#### Addendum No. 4 to the Contract Documents

# JVWCD Headquarters Upper Campus Site Repairs & Improvements Project

To All Planholders April 10, 2021 Gentlemen: Project No.: 3910 The following changes, additions, and/or deletions are hereby made a part of the Contract Documents for the construction of the "JVWCD Headquarters Upper Campus Site Repairs & Improvements", dated March 3 2021, as fully and completely as if the same were fully set forth therein: A. The Bid Schedule replaces ALL previously published Bid Schedules. The Bid Schedule attached to this Addendum No.4 must be used for when bidding on this project. B. Drawings: UTILITY PLAN BECKSTEAD LANE, drawing page 4.3, replaces the previously published drawing UTILITY PLAN BECKSTEAD LANE, drawing page 4.3. **C.** Drawings: UTILITY PLAN GAS LINE, drawing page 4.5, replaces the previously published drawing UTILITY PLAN GAS LINE, drawing page 4.5. **D.** The attached document titled "TCC Response to Comments Jordan Valley Water Conservation District Headquarters Upper Campus Improvements Project" is added and made integral part of the Bid Documents. E. The attached document titled "UNIT PRICE – MEASUREMENT AND PAYMENT", replace

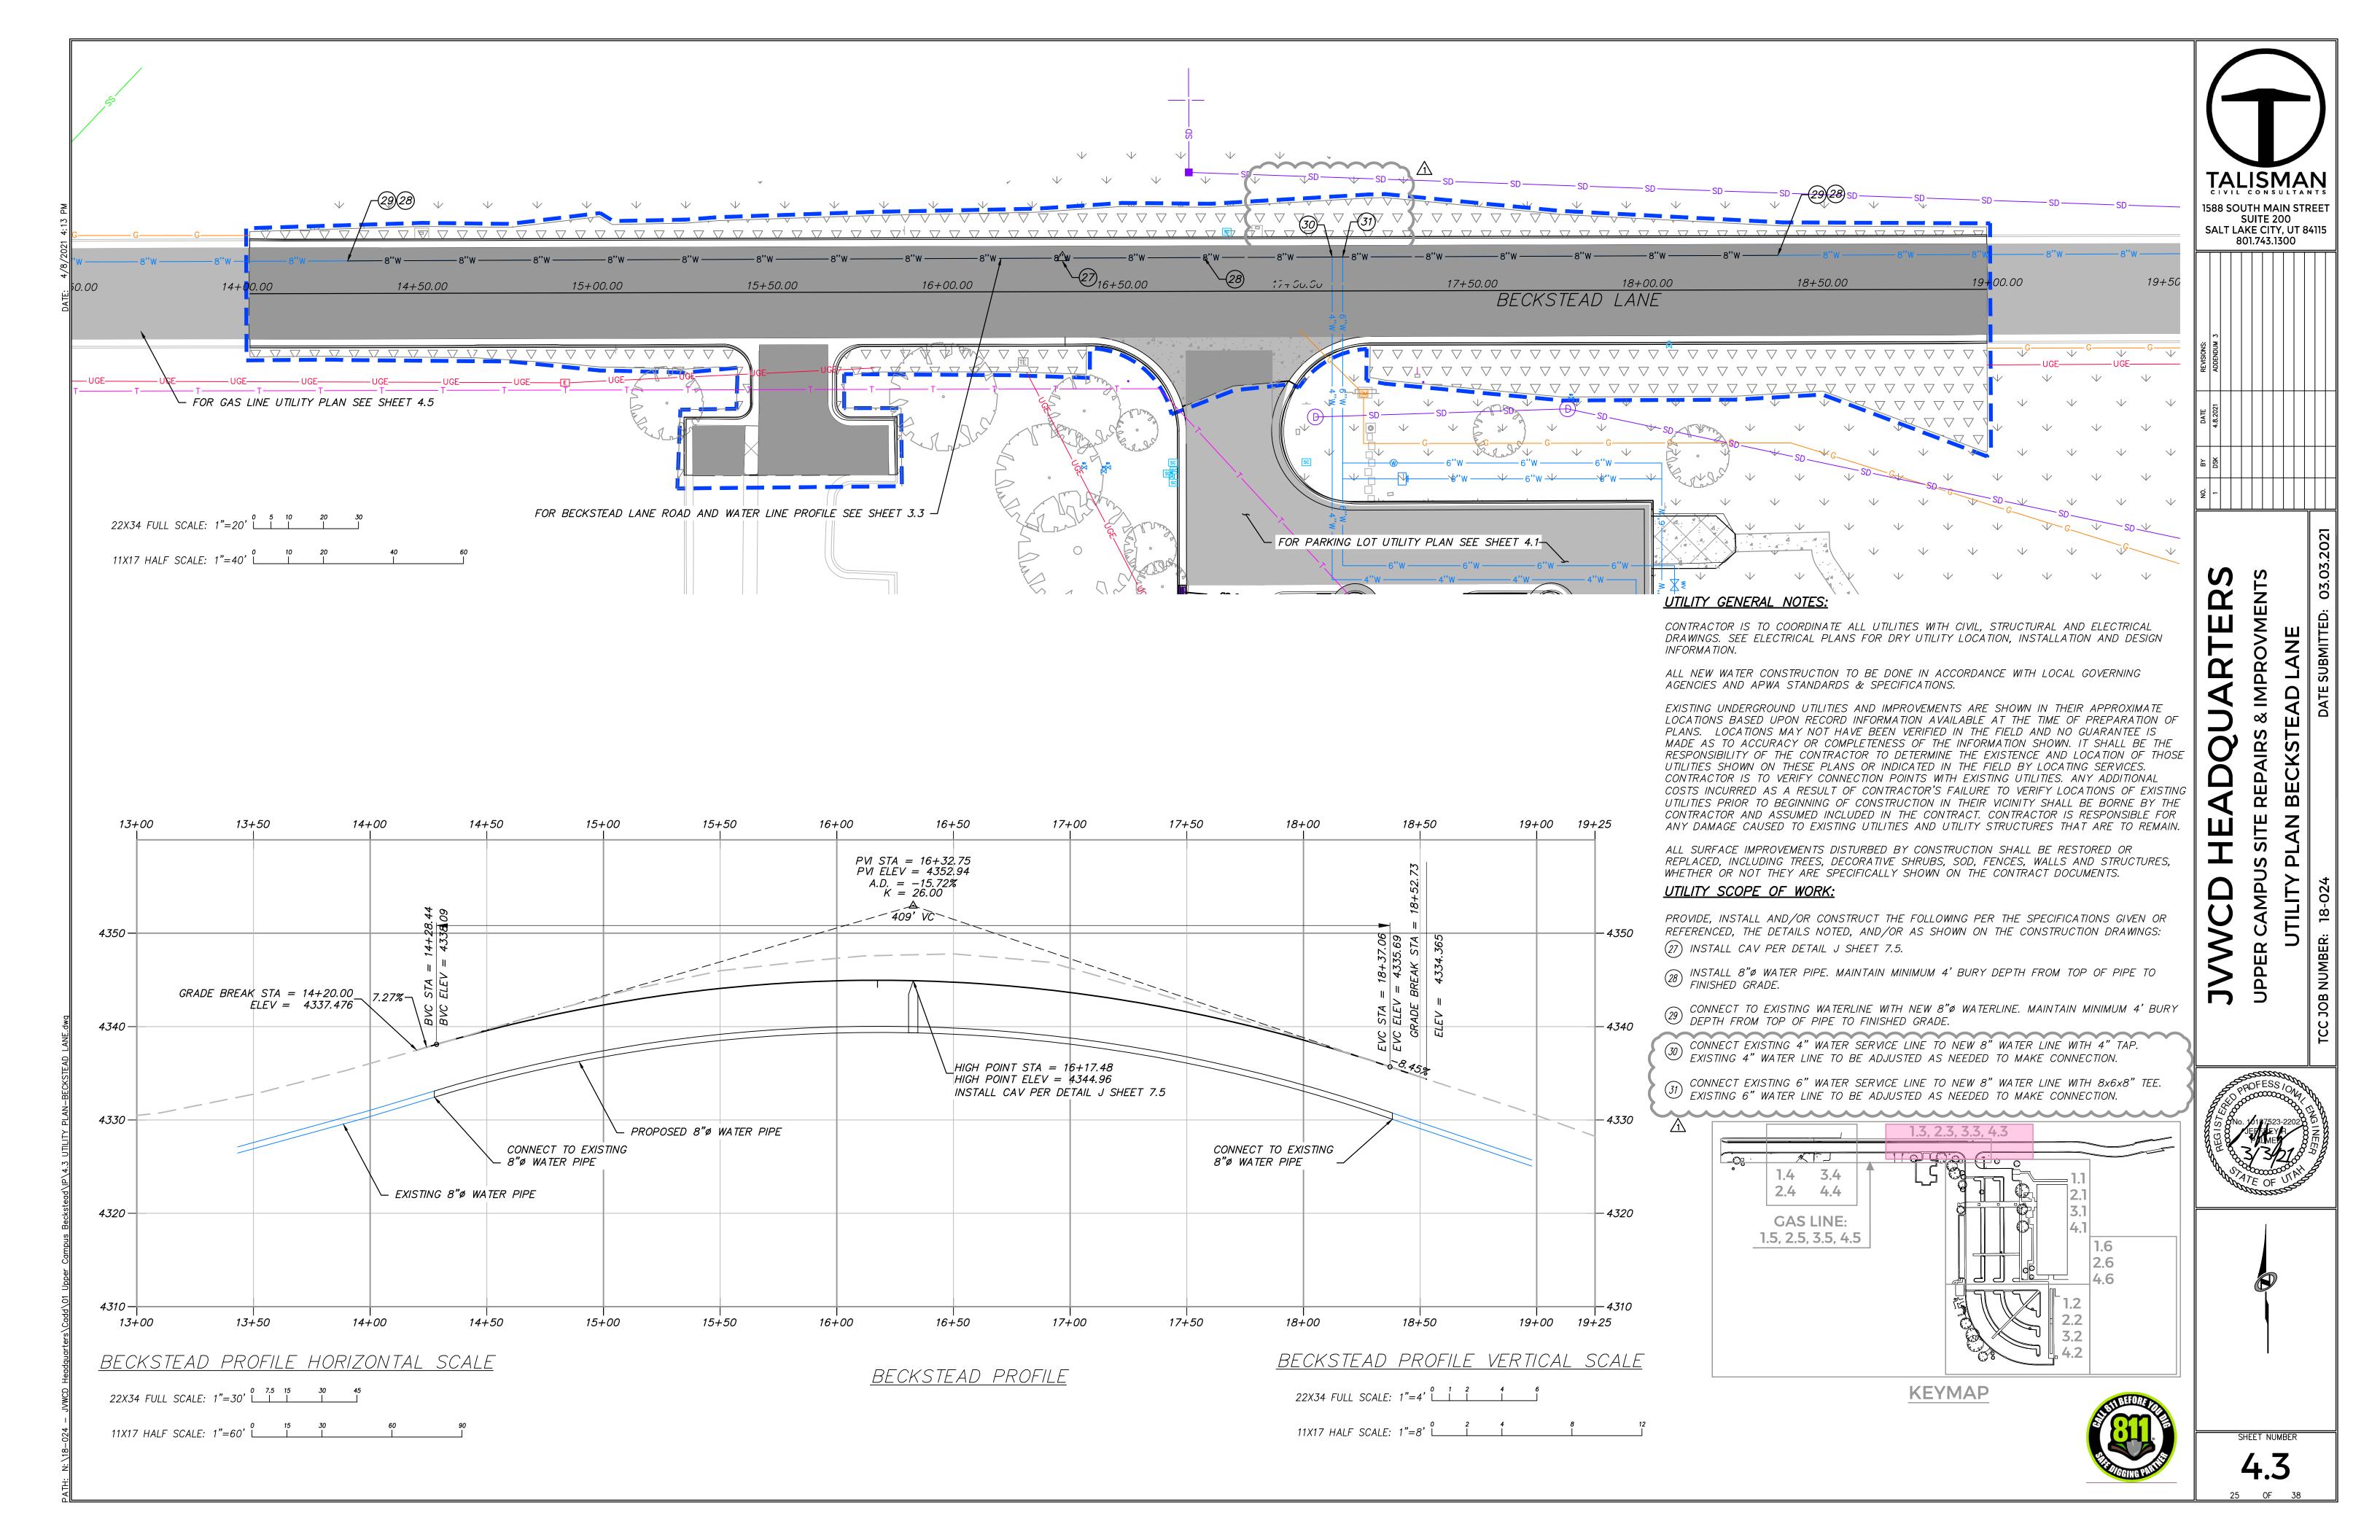
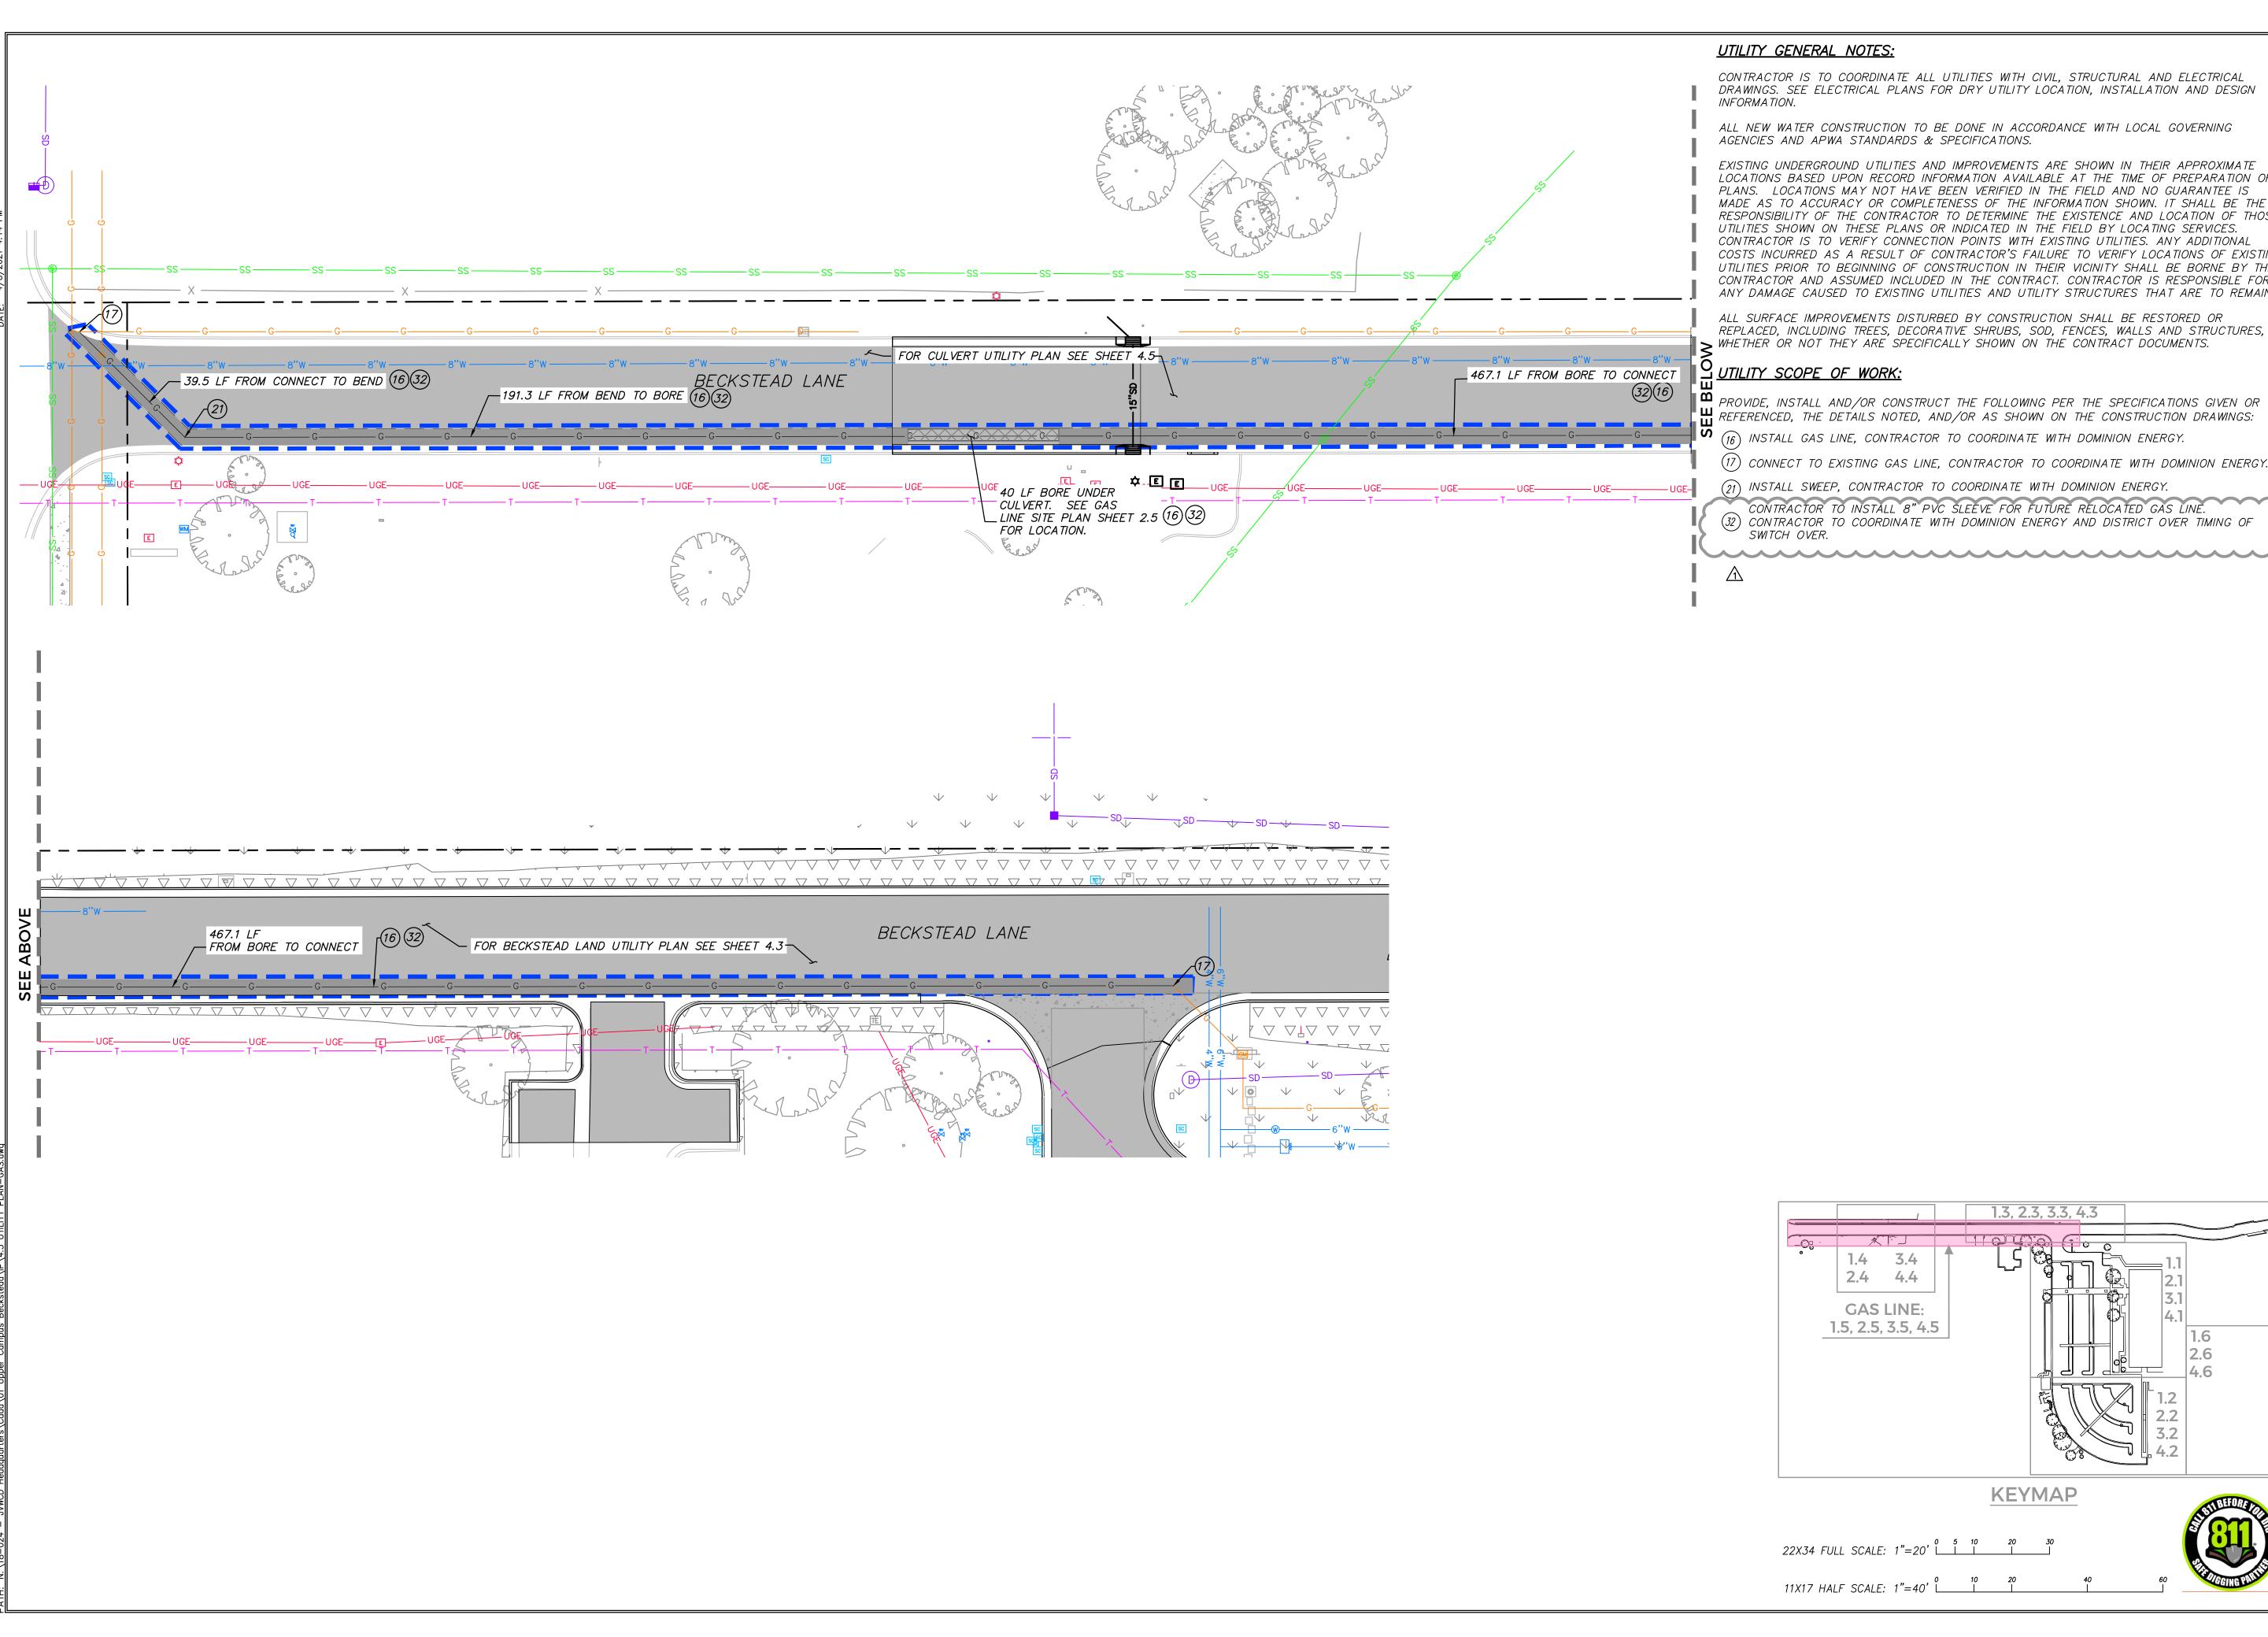
(17) CONNECT TO EXISTING GAS LINE, CONTRACTOR TO COORDINATE WITH DOMINION ENERGY.

- (21) INSTALL SWEEP, CONTRACTOR TO COORDINATE WITH DOMINION ENERGY.
- CONTRACTOR TO INSTALL 8" PVC SLEEVE FOR FUTURE RELOCATED GAS LINE. (32) CONTRACTOR TO COORDINATE WITH DOMINION ENERGY AND DISTRICT OVER TIMING OF
